**RESOLUTION NO. 2019-50**

TO: Village of Caledonia Planning Commission  
 CC: Tom Christensen, Elaine Ekes, Jarmen Czuta  
 FROM: Jeff Muenkel AICP  
 RPT DATE: April 18, 2019  
 MTG DATE: April 29, 2019  
 RE: "Anderson Trailers" – Town of Raymond Coop Boundary Request

## Staff Review

SHEET NUMBER  
 A1 OF A1

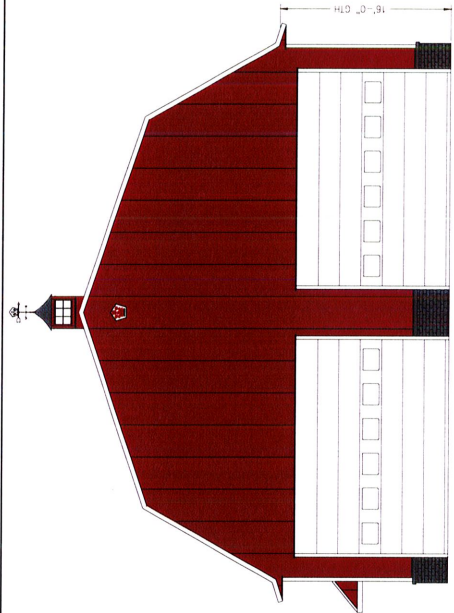
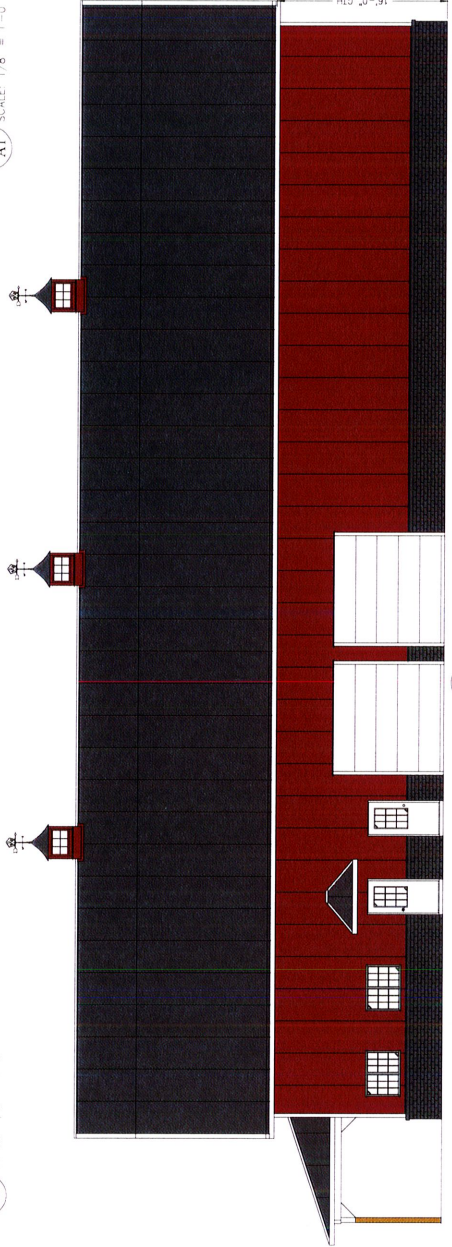
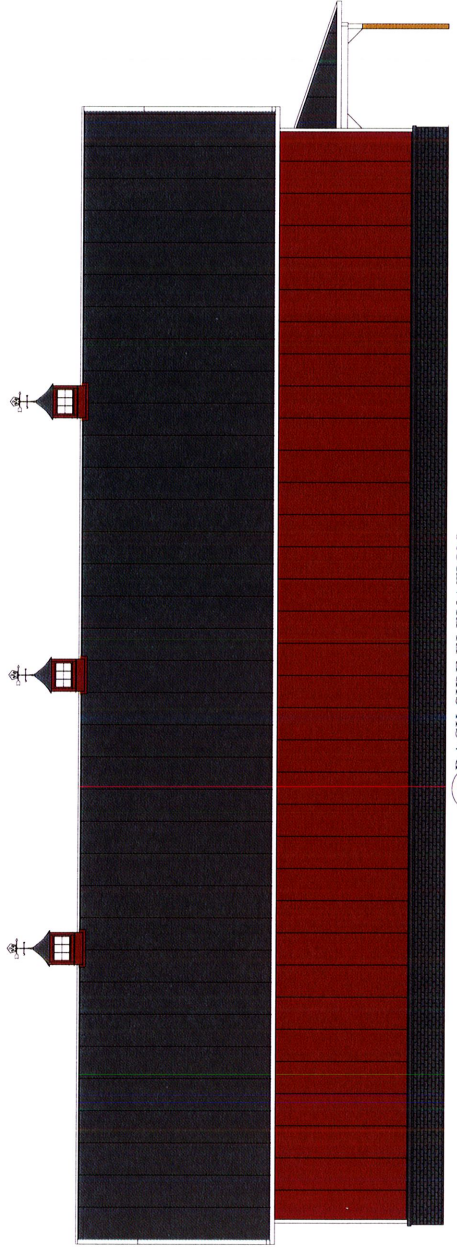
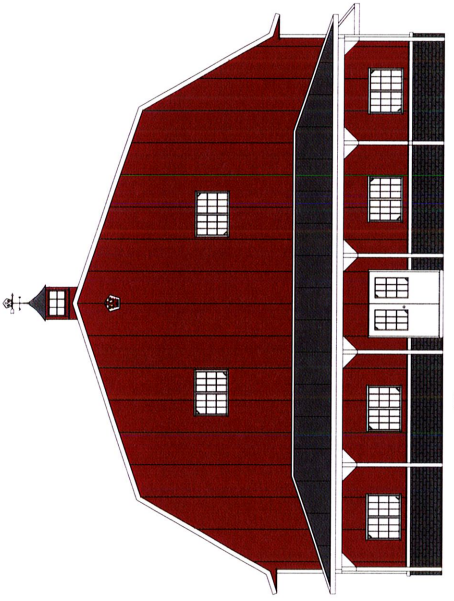
The newly proposed commercial structure building elevations are found attached and depict a 5,200 square foot barn-type architecture structure that will house Anderson Trailers needed office and warehouse space. The structure is proposed to be constructed with metal siding with a red color on the sides and a grey color for the roof. A 3-foot band of brick wainscoting is to be found along the entire base elevation of the structure. An overhang and multiple windows are found on the "left end" elevation. The "front" side elevation has two (2) smaller overhead doors with a couple windows and access doors. The "right side" elevation will have two large overhead doors occupying most of the façade and the "back" elevation will not have any features.

- a. The smaller two (2) overhead doors along the north elevation will be internal to the fenced in storage yard. The two (2) large overhead doors on the west elevation will be totally out of view from the roadway and will also be internal to the fenced in storage yard.

2. Four Sided Architecture Required – Requires similar architecture and use of materials throughout all facades of a proposed structure.
  - a. The proposed utilizes four-sided architecture subject to any Plan Commission discussion on types of materials being used per sub section 5 below.

- a. A standing seam metal roof is proposed. These types of buildings are commonly found along the 27<sup>th</sup> St frontage road here. Given that the building will be new and next to residential structures the proposed should be fine and appropriate but subject to Plan Commission discussion.

- a. A metal façade with a 3-foot band of wainscoat brick is found throughout the structure. As previously noted, commercial metal buildings are common along the 27<sup>th</sup> St frontage road here. Given that the building will be new and next to residential structures the proposed materials may work well in the area. However this is subject to Plan Commission discussion and changes since the proposed does not technically meet this requirement outright at this time.

6. Building Placement – Requires building facades to be parallel or perpendicular to the right-of-way.
  - a. The proposed new structure is perpendicular.

1. All rooftop mechanicals shall be screened upon construction with similar architectural materials found on the principal structure.

PLAT OF SURVEY  
-OF-

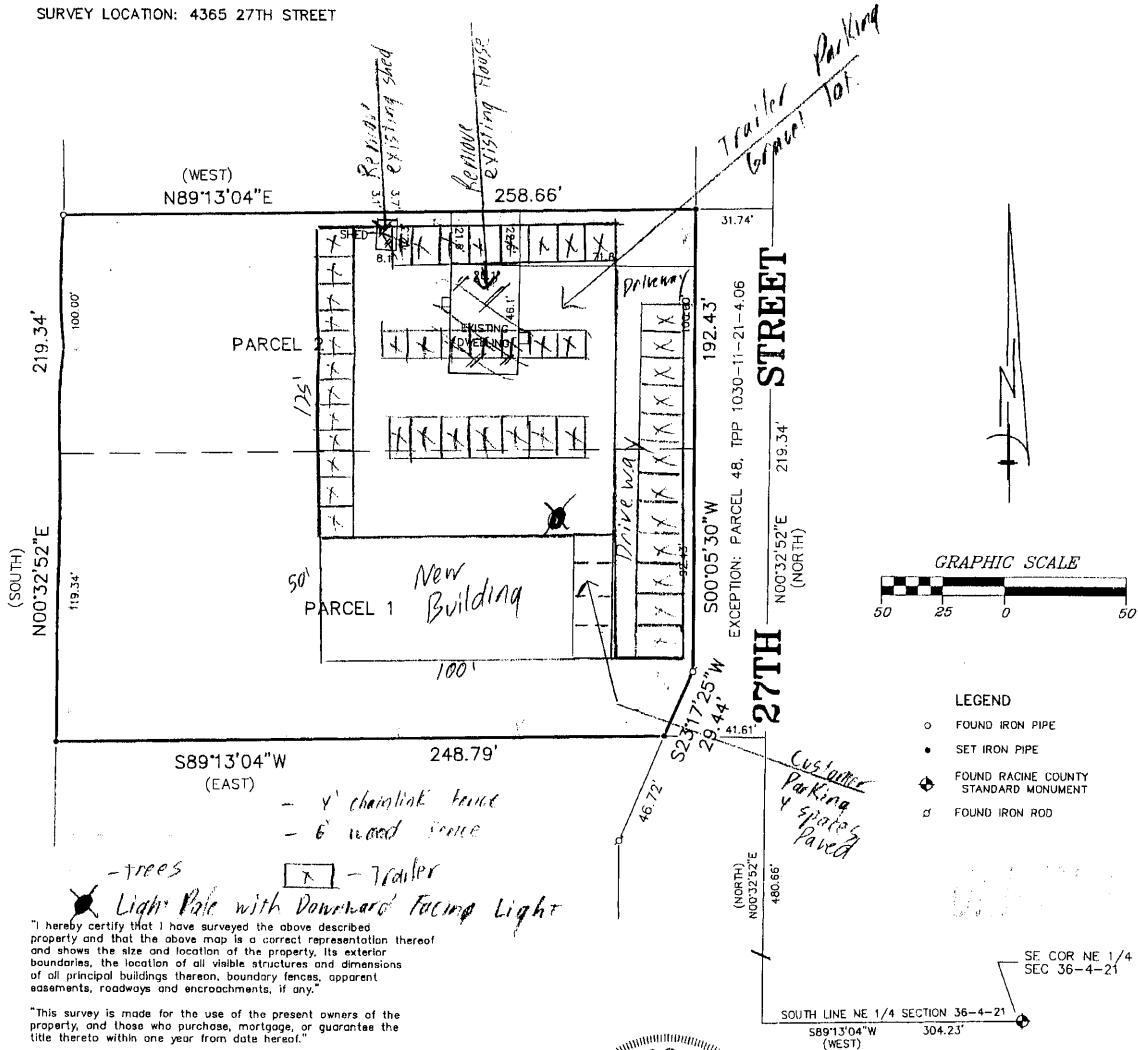
The site plan is updated since the utilization of the former residential structure is now removed. The site plan shows a frontage driveway that accesses off of 27<sup>th</sup> Street to the new structure on the south side of the property. The northern rear portion of the property will still be used for storage and the frontage of the property will be used for employee/patron parking.

1. A landscape plan shall be approved as part of a future zoning permit that incorporates street edge landscaping with mature trees planted at least every 50' on center parallel to the right-of-way. Such trees shall be planted in front of the fence enclosure along the 27<sup>th</sup> Street right-of-way.
2. Any required ground mechanical equipment, misc. outdoor storage, or refuse containers shall be screened by landscaping or fencing.
3. Any future outdoor lighting shall be down-cast cut-off fixtures. Any pole lights shall not exceed 20 feet and shall have a concrete base of no more than 6" above ground. Lights should produce no more than 0.5 foot candles at the property line with no lighting to exceed 12 foot candles.
4. The patron/employee parking and driveway shall be hard surfaced while the enclosed trailer space can be gravel as shown.
